# ADDENDUM

addendum No. 6

Project No. <b>4-001-674</b>	Project Title <b>Hall Beach Water Supply and Truckfill Station</b>
Division/Region <b>Projects / BAFFIN</b>	Client <b>MACA / Dept. of National Defence</b>
Community <b>Hall Beach, NT</b>	Date of Issue <b>April 28, 1998</b>
Contractor <b>ALL BIDDERS</b>	Consultant <b>Dillon Consulting / Frontec</b>

FOX-M  
XL-66012  
WATER RESERVOIR  
SK-XL-66012-R1

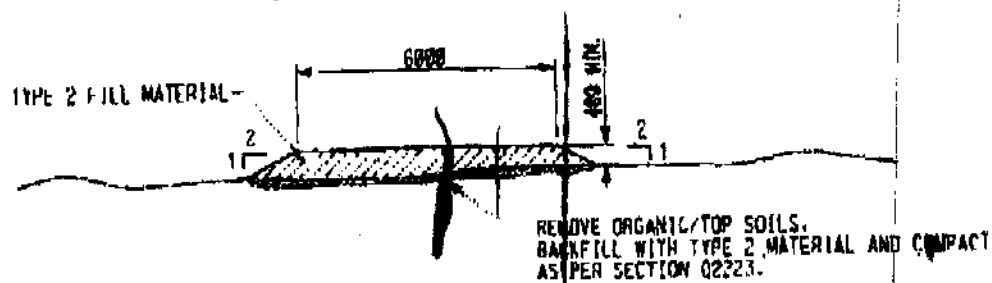
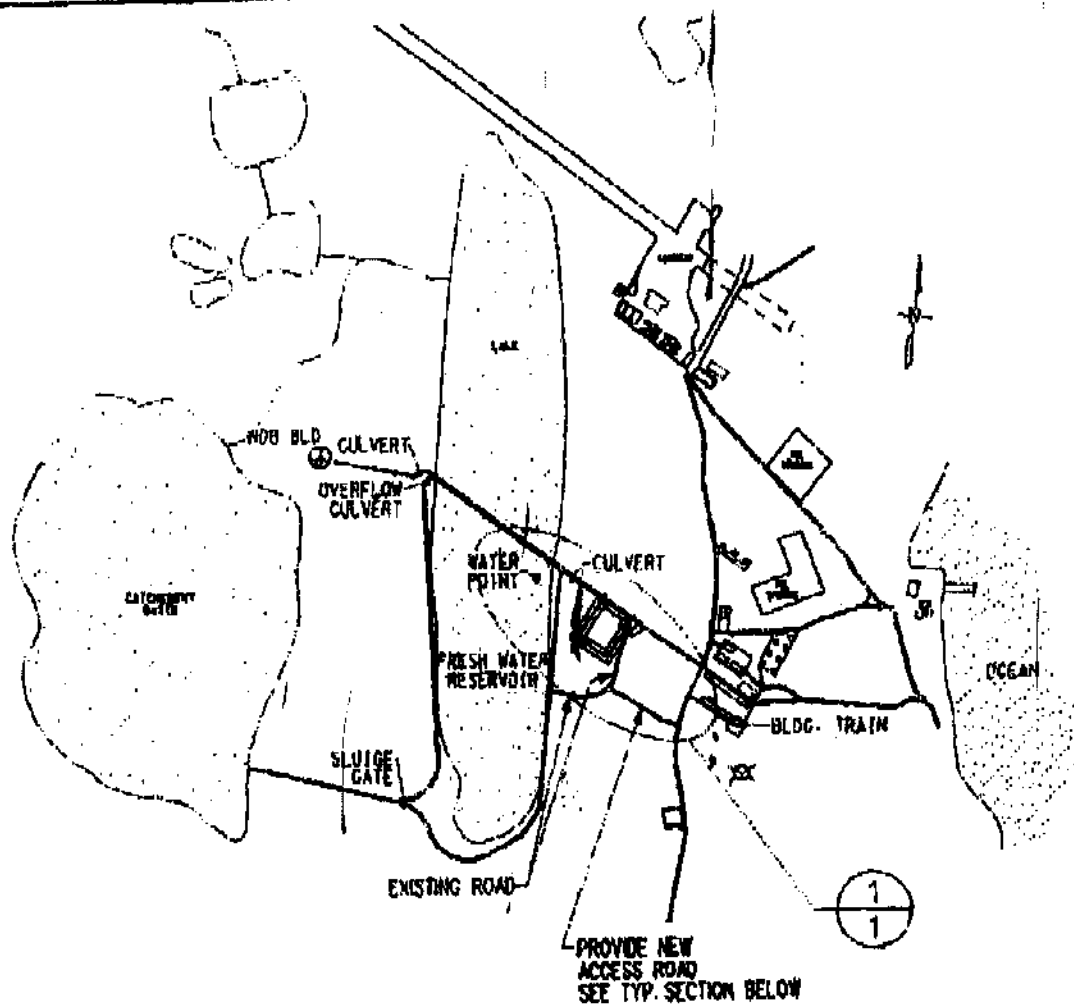
9. Reference Part B, Section 02230, Page 2, Aggregates General, Items 2.2.1 and 2.2.2
  - Note ; THE MATERIAL IS REQUIRED TO BE CRUSHED
10. Reference Part b, Drawing SK-XL-66012-1

- The attached sketch SK-XK- 66012-R1 clarifies the extent of work required for the new access road construction.
  - Add 655 cubic meters of Type 2 fill to appendix D which will increase to total estimated quantity of type 2 material to 91, 955 cubic meters.

NOTE: APPROX. LENGTH OF THE NEW ACCESS ROAD IS 240m
